## MEMORANDUM

October 7, 2015

**SUBJECT:** Public hearing and consideration of a Landmark Alteration Certificate to construct a 405 sq. ft. addition to the main house, modify the fenestration on the south elevation, and construct a new 280 sq. ft. free-standing, one-car garage, per Section 9-11-18 of the Boulder Revised Code 1981 (HIS2015-00232).

1. Site: 800 Arapahoe Ave.
2. Designation: Individual Landmark, Hannah Barker House
3. Date of Construction: c. 1878
4. Zoning: RMX-1 (Residential Mixed-1)
5. Lot size: 7,632 sq. ft.
6. Existing House: 2,300 sq. ft. (approx.)
7. Proposed Addition: 405 sq. ft.
8. Proposed Garage: 317 sq. ft.
9. Applicant: Steve Dodd, Architect

Figure 10. Proposed Site Plan (new construction highlighted in blue)

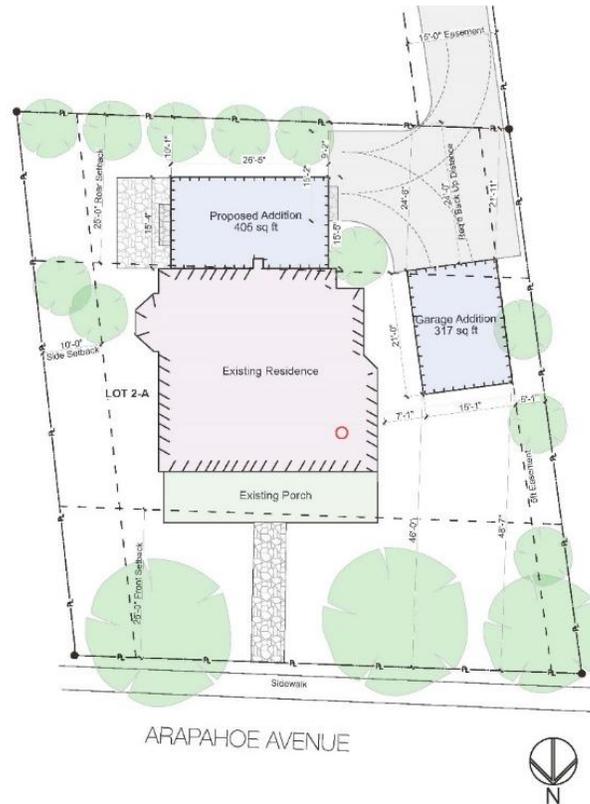
Staff considers that the proposed construction of the new accessory building to be generally consistent with Sections 2.0 and 7.2 of the *General Design Guidelines*. Due to the configuration of the lot, the proposed location is as close to the rear property line as possible to achieve the required 24' vehicle back out distance. The one-story, 317 sq. ft. garage is diminutive in size and simple in detailing. Staff considers that the construction of the garage will not damage or destroy the architectural or historic character of the landmarked site. Staff recommends that the applicant explore locating the garage as close to the rear property line as possible to further lessen the visual impact from Arapahoe Ave.

- (E) Consideration of moving the garage further south, as close to the rear of the property as possible.
3. The Landmarks design review committee shall review details regarding the new construction, including materials, door and window details including moldings, and proposed insets, railing details, paint colors, and hardscaping on the property to ensure that the approval is consistent with the *General Design Guidelines* and the historic preservation ordinance.

*Figure 11. Existing and proposed changes to the fenestration at the south (rear) elevation.*

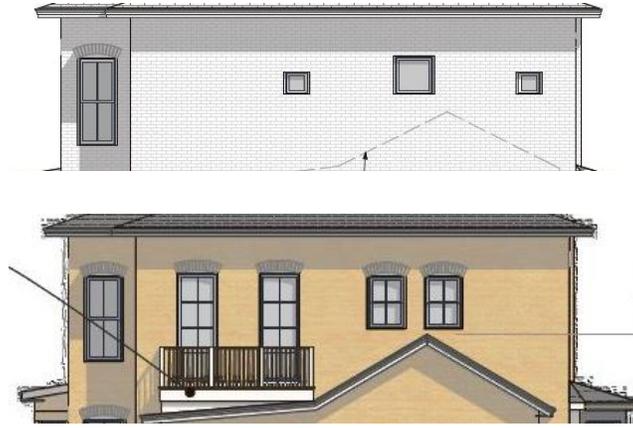
Elevations for the south (rear) elevation shows the reconfiguration of the window openings on the upper level of the main house. The application proposes to brick-in the three existing windows on the second level of this elevation. Physical evidence and historic photographs indicate that the existing openings are original and have not been enlarged or reduced in size. The larger, middle window has a wood sill. Currently boarded over, the windows were each single-pane, fixed windows. The glass of each of the windows has been broken or is altogether missing.

Plans show that four new openings would be made: a pair of 2-over-2 double-hung windows near the peak of the gable of the addition, and two openings at the west end of the elevation, similar in proportion to the historic openings on the house. Details on

Staff considers the proposed reconfiguration of the fenestration on the south elevation to be inconsistent with the historic preservation ordinance and Section 3.7 of the *General Design Guidelines* and the three window openings on the south elevation to be “Historically Important Windows” as they are likely original to the construction of the house and have not been significantly altered. The General Design Guidelines defines a Secondary Elevation as “typically a side of a building that has less public visibility, and may have fewer significant character defining features than on the façade. An elevation that has visibility from an alley may be considered a secondary elevation.” Staff considers the south elevation to meet this definition.

Staff considers that the removal of the three window openings will adversely affect the historic integrity of the property, as the window openings are original to the house and the design guidelines discourages the removal or relocation of window openings. Staff considers that a single opening to access the roof deck would be appropriate on the west side of the south elevation. Staff suggests that the door opening be simplified to avoid confusion about the date of the proposed modification. This may include removing the decorative sills.

- (A) Retention of the three windows at the south elevation of the main house.
  - (B) Elimination of the two new window openings at the south elevation of the main house.

Figure 13: Proposed South Elevation (Rear)

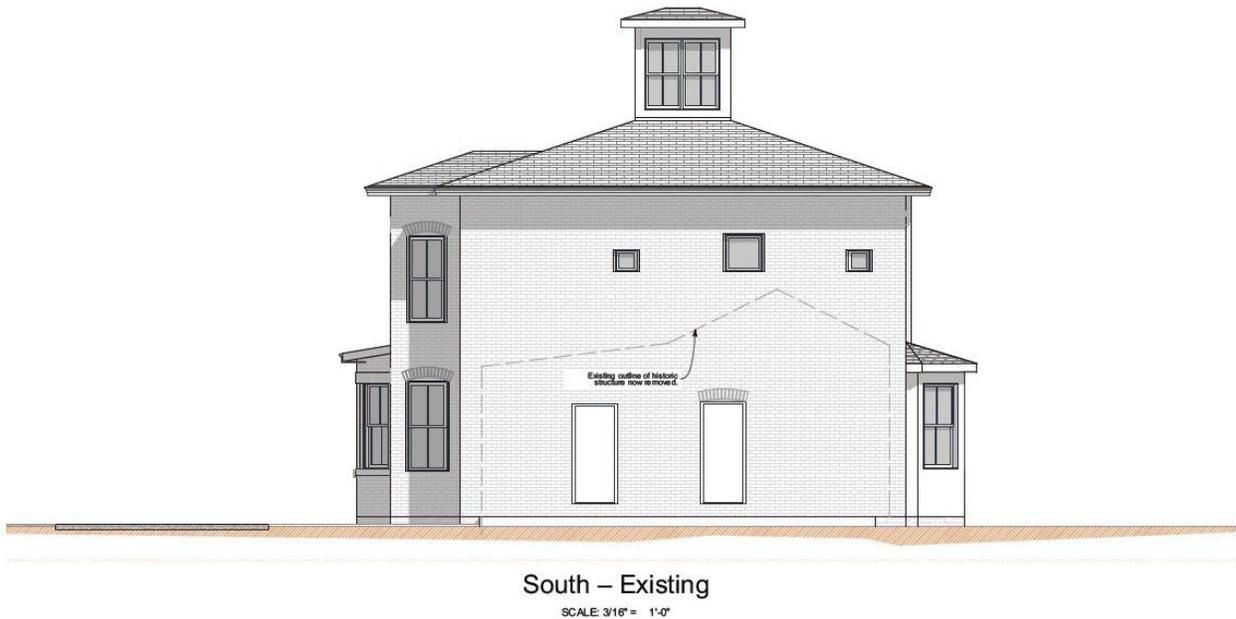
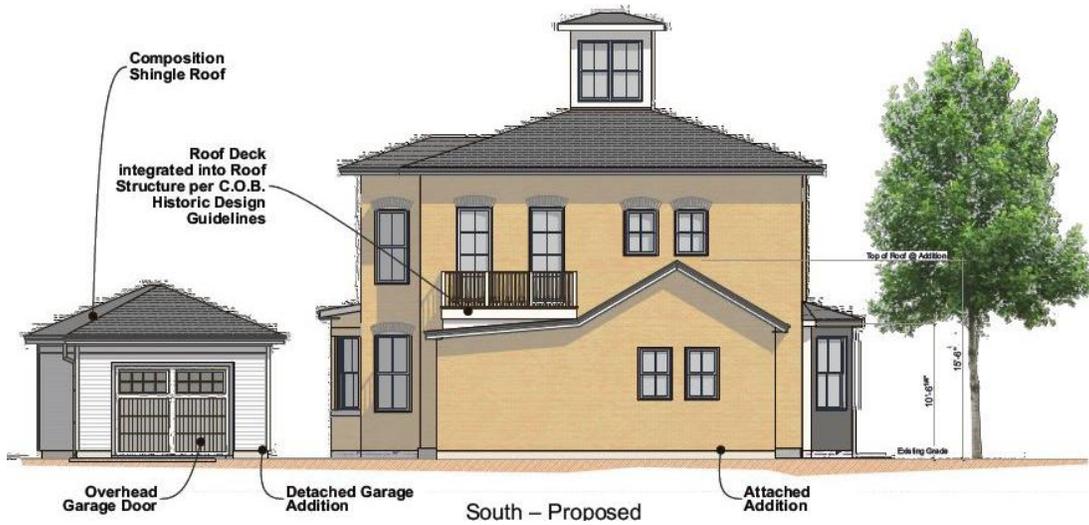
The addition, as shown, references the roof pitch, height and width of the pre-1875 masonry building with the length of the building measuring approximately 15', or approximately three-quarters the length of the original portion. A pair of double-hung windows is shown to be centrally located beneath the gable end on the south elevation of the addition.

A roof deck is shown to be integrated into the roof structure of the addition at the west end of the elevation. It is shown to measure 5'x10' and have simple, wooden vertical supports.

Staff considers that the proposed construction of a rear addition is generally consistent with Sections 3.2 and 4.0 of the *General Design Guidelines*. The one-story, 405 sq. ft. addition to the two-story, 2,300 sq. ft. addition will not detract from the overall historic character of the building and will not require the removal of significant building elements or site features. The proposed addition references, but does not replicate an earlier addition and is compatible with the symmetry of the original house. The addition is not prominently visible from Arapahoe Ave., and its scale and massing will not visually overwhelm the historic building. The proposed materials are appropriate, and the addition will be discernable from the historic portion of the building through simplification of window openings and material detailing. Staff recommends that the roof deck be further integrated into the roof structure of the proposed addition to meet Guideline 3.2.2.

In further discussions of the roof form, it was suggested that the bedroom deck might not fit into the roof as much as the General Design Guidelines (that adhere to the Secretary of Interior's Standards) envision. A modified roof form might resolve massing concerns while also improving the deck's relationship with the roof plane.

- (C) Modification of the plans to include a single door at the deck rather than two new openings.
  - (D) Further integration of the deck into the roof structure of the addition.
